DEVELOPMENT ASSESSMENT REPORT – DA020/19 - PROPOSED SUBDIVISION - 1 LOT INTO 4 and 4 DWELLINGS, LOT 6 DP 1250061, 7 CURA CLOSE LITHGOW NSW 2790

To assess and recommend determination of DA020/19. The recommendation is for refusal.

Figure 3: Subdivision Layout Plan

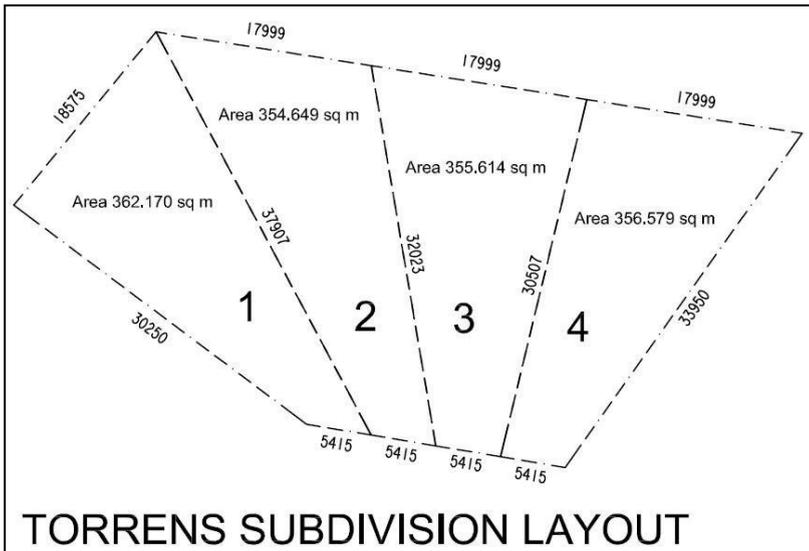
The proposed lots are irregular in size and configuration with a long, north-south orientation. The lots contain an average frontage width of 5.4m, in comparison with the current lot width of approximately 21m. The proposed lot widths will contribute to poor built form, poor private open space and poor privacy of the proposed dwellings. The proposal does not provide for an adequate lot configuration, size or width.

In comparison to subdivision requirements set out in AMCORD (once again used as a resource guide to assist in assessment) (Element 5.2 Lot Layout, page 153) provide for Lots with an area of between 300m² – 450m², capable of containing a rectangle measuring 9m by 15m. The proposal does not meet this provision and provides for splayed lots with narrow lot frontages, splaying to a wider rear area. This in turn affects the building configuration and is unable to achieve adequate private open space as well as poor presentation to the streetscape.

The proposal does not provide for an adequate lot configuration, size or width.

Figure 5: Elevation of Proposal from Cura Close

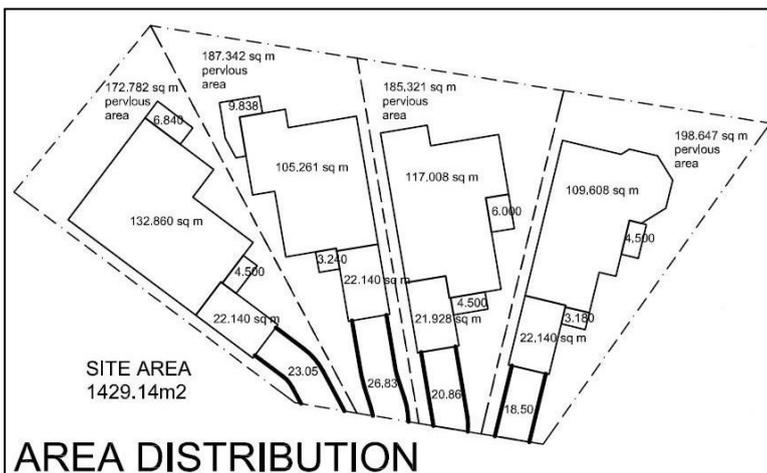
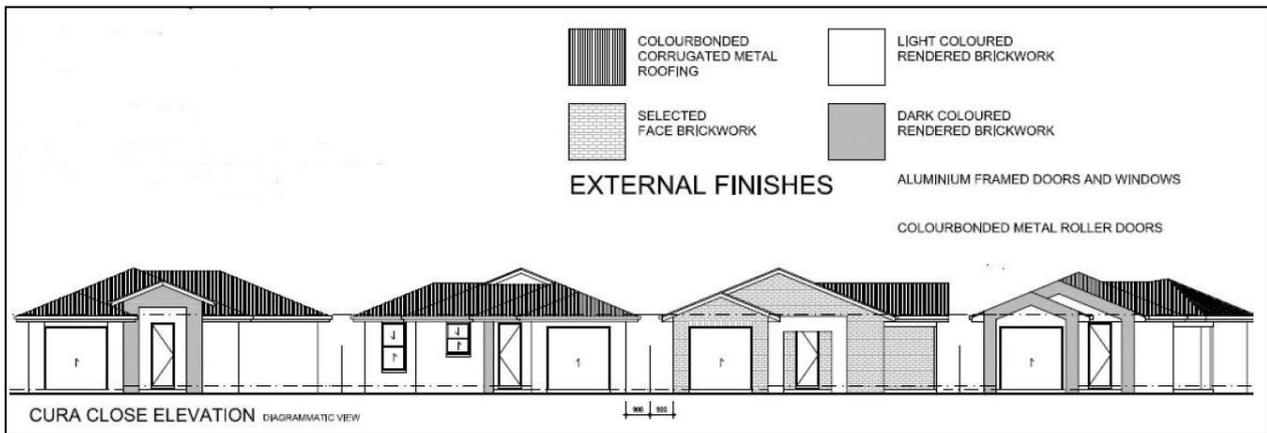
It should be noted that the front elevation above is not representative of the presentation of the proposed four dwellings to the street. A 3D view is included later in this report.

The applicant has failed in the design of the new dwellings to locate the garages on the site in an appropriate location. The proposed location will diminish the attractiveness of the streetscape.

The garages are positioned well in front of the proposed dwellings and will dominate views of the dwellings from the street. This in turn will reduce the opportunity for surveillance of the street from dwellings with restriction of views of the buildings from the street. The applicant supplied a three dimensional view as below. The compressed view from the street supports the view that the single dwellings represent an over development. In response to discussions the applicant did include some additional landscaping detail and design elements. However, this has not been able to resolve the impact that is inherent in the overdevelopment.

Figure 6: Proposed Landscape Plan

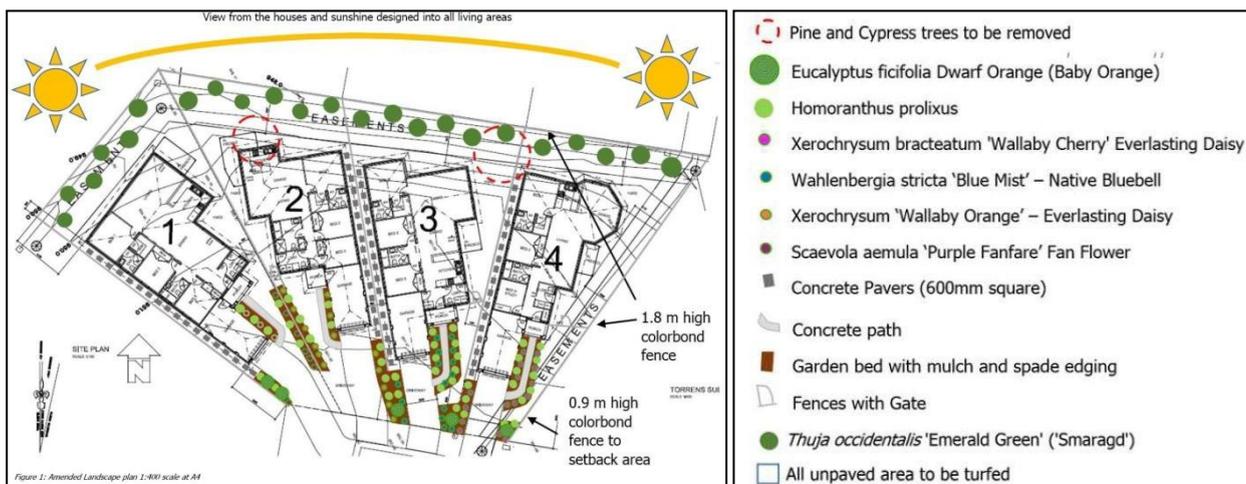
The applicant provided a landscaping plan that indicates the northern and western elevations proposed to be landscaped with *Thuja occidentalis* 'Emerald Green' ('Smaragd'), an upright growing conifer growing to a maximum height of 5m. With the provision of this landscaping, sporadically planted along the boundaries there will still be loss of privacy and overlooking from the dwellings into the adjoining residential backyard areas (Short Street neighbours).

Figure 11: Photo montage provided by applicant

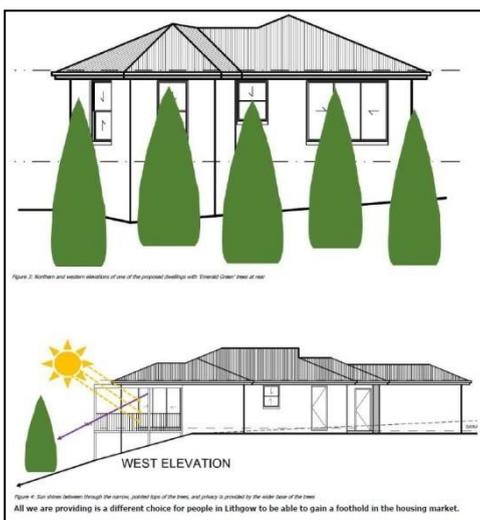
While the landscaping is likely to alleviate a small degree of privacy and overlooking to adjoining neighbours, it is unlikely that the density of landscaping can be achieved to resolve the concerns. It appears likely that there will still be privacy loss and overlooking from the dwellings into the adjoining residential backyard areas.

The applicant has provided some sectional details and a photo montage of the landscape treatment.
